Field Alternatives Review

Prepared for: Nevada Department of Transportation

May 3, 2012

USA Parkway
SR 439

EXHIBIT 1: SPECIFIC LOCATIONS OF INTEREST

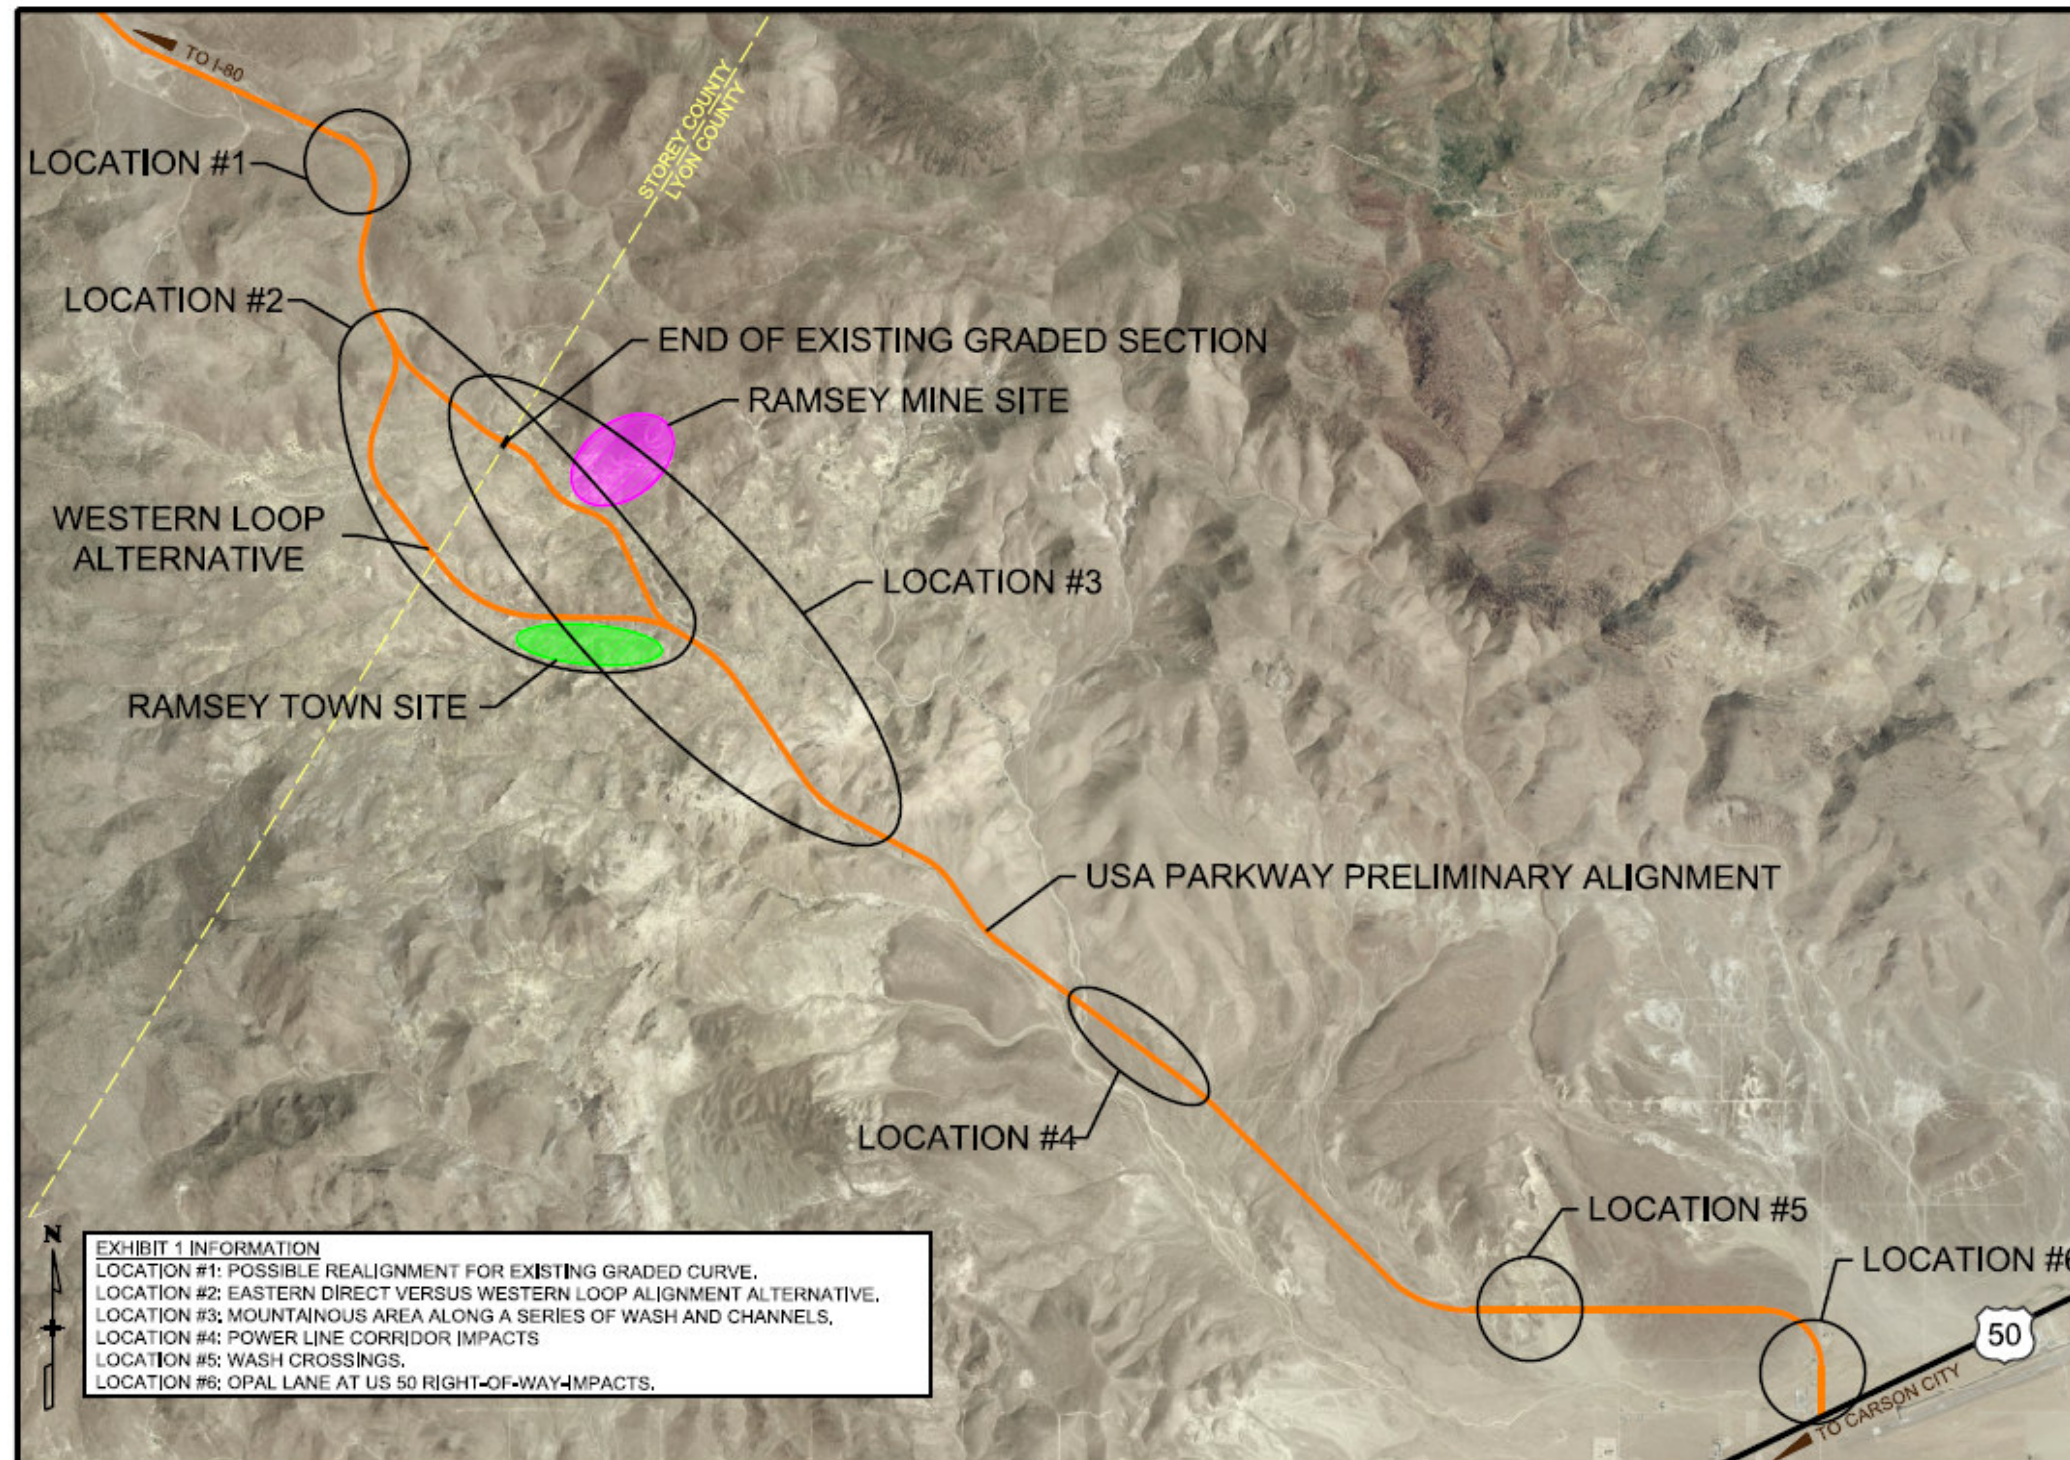
During the February field visit, the project team identified six specific locations where additional design analysis was needed to further refine the alternatives and resolve specific issues. These six locations are listed below with a brief description of the issues encountered at each site. Exhibit 1 on the following page shows the locations of these sites in relation to the overall project with stations given corresponding to the plan set in Appendix B. Also, the photo log included in Appendix A depicts these areas and is helpful in clarifying the issues discussed below.

- **Location #1: The reversing curves along the graded portion of the roadway, at stations 510+00 to 620+00.**

- **Location #2: The western loop alternative versus the eastern direct alternative, stations 375+00 to 520+00.**

- **Location #3: The mountainous section from the Storey / Lyon County line to where the alignment meets the valley floor, stations 310+00 to 465+00.**

- **Location #4: The power line corridor, stations 210+00 to 280+00.**

- **Location #5: A series of wash crossings, inaccessible by vehicle, stations 110+00 to 155+00.**

- **Location #6: The connection with US 50 at Opal Lane, stations 10+00 to 30+00.**

EXHIBIT 2
LOCATION #1: REVERSING
CURVES
55 MPH VS 60 MPH ALIGNMENTS

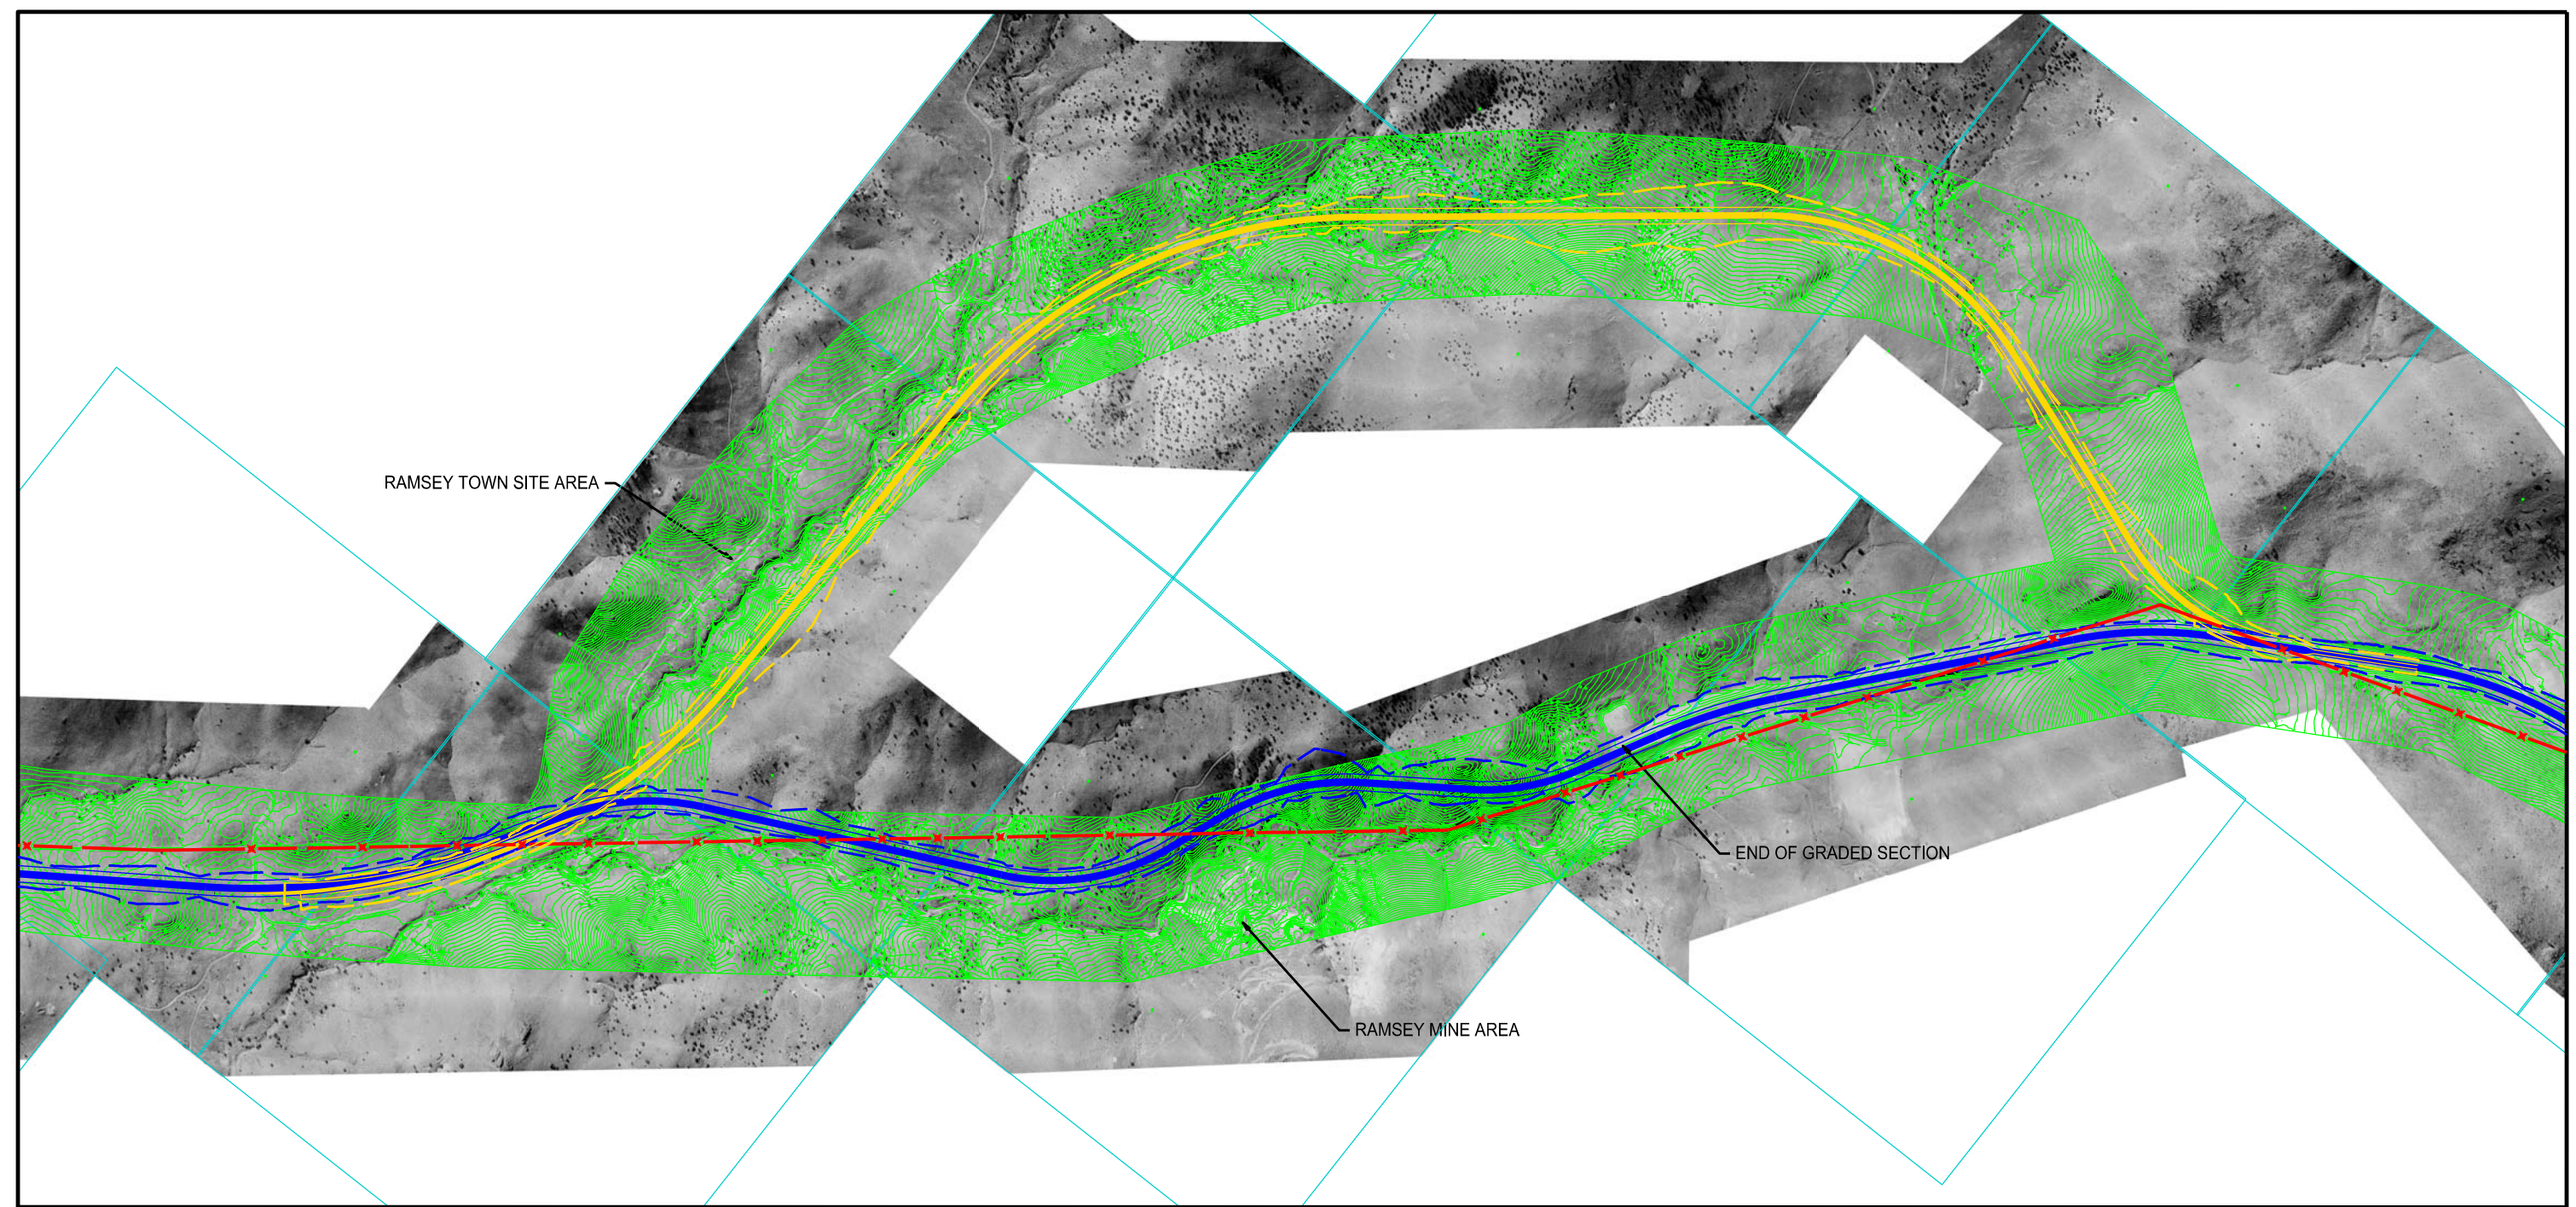
- **Location #1: The reversing curves along the graded portion of the roadway, at stations 510+00 to 620+00.**

As discussed in Section 5, the horizontal geometry of the existing graded section of roadway through this area meets a 55 mph design speed, but fails to meet the proposed 60 mph design speed. A proposed realignment of the roadway in this location to develop an alignment that meets the 60 mph design speed was developed and is depicted in blue line work on Exhibit #2 on page 11.

Preliminary earthwork estimates indicate the additional grading required to construct the alternate alignment in this location consists of roadway excavation of 549,000 cubic yards and embankment of 80,000 cubic yards, which generates excess cut in the amount of 469,000 cubic yards. The overall preliminary earthwork quantity for the project currently reflects the need for a significant amount of borrow material. The excess material from the subject realignment could be utilized to make up this difference. It is anticipated, however, that additional alignment refinements through the mountainous areas discussed in Location #3 below will reduce the amount of excess borrow required. In addition, NDOT is considering the use of a material source in close proximity to the southern section of USA Parkway alignment which could provide additional borrow material with a shorter haul distance.

Once earthwork quantities for the selected primary new alignment have been developed and the likelihood of a material source on the project has been assessed, a cost / benefit analysis will be performed to determine if the 5 mph increase in design speed is worth the additional cost of re-grading the roadway. If the excess material from the subject realignment is not necessary to balance the grading on the overall project, the disposal costs for removing the material from the project will be

significant. It will be NDOT's decision whether those costs are justified in providing a 5 mph increase in the design speed of the roadway.

As mentioned previously, if the existing graded alignment is not altered, the design speed of the curves would still match the proposed 55 mph posted speed currently proposed for the new alignment section of USA Parkway.

EXHIBIT 3
LOCATION #2: EASTERN DIRECT
AND WESTERN LOOP ALIGNMENT
ALTERNATIVES

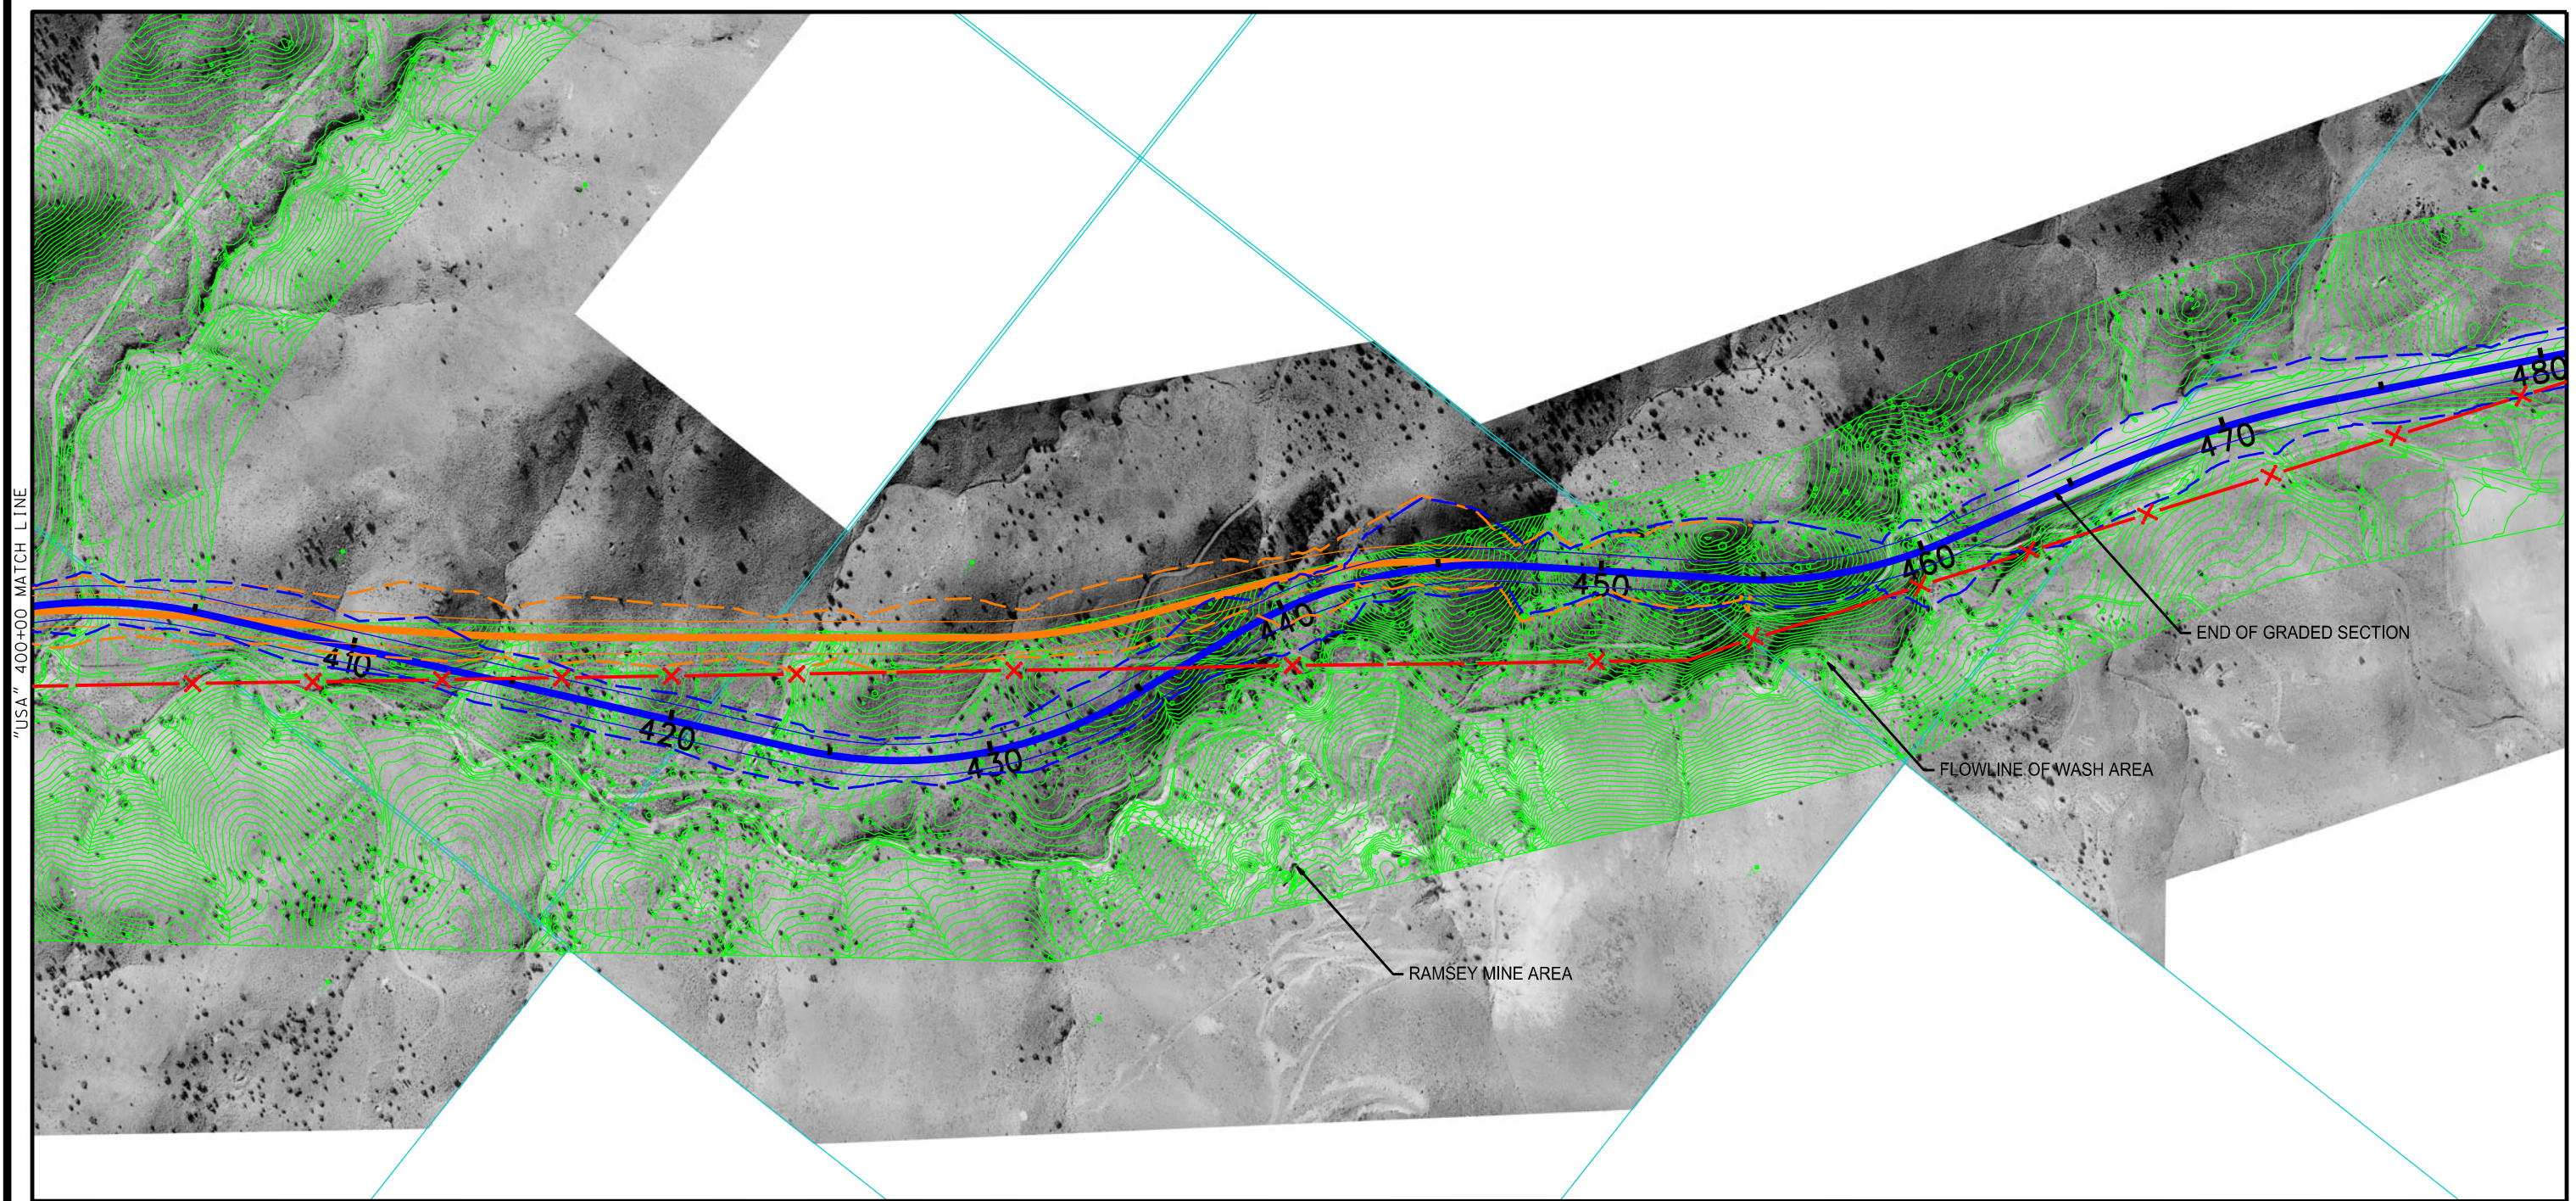
- **Location #2: The western loop alternative versus the eastern direct alternative, stations 375+00 to 520+00.**

As shown in blue line work on Exhibit #3 on page 12, the direct alternative is approximately 0.6 miles shorter and approximately one-third of this alignment has already been graded. The western loop alternative, shown in yellow line work on Exhibit 3, produces approximately 1.4 million cubic yards of additional earthwork when compared to the eastern direct alternative.

In addition, the western loop alignment passes very close to the Ramsey town site and may impact some of the potentially historic aspects of this site. Even though the eastern alternative passes near the abandoned Ramsey mine, it is not anticipated to have the same impacts to existing features.

Based on the design analysis as well as comments and discussions generated from the field review, the project team recommends that the western loop alternative be eliminated from consideration.
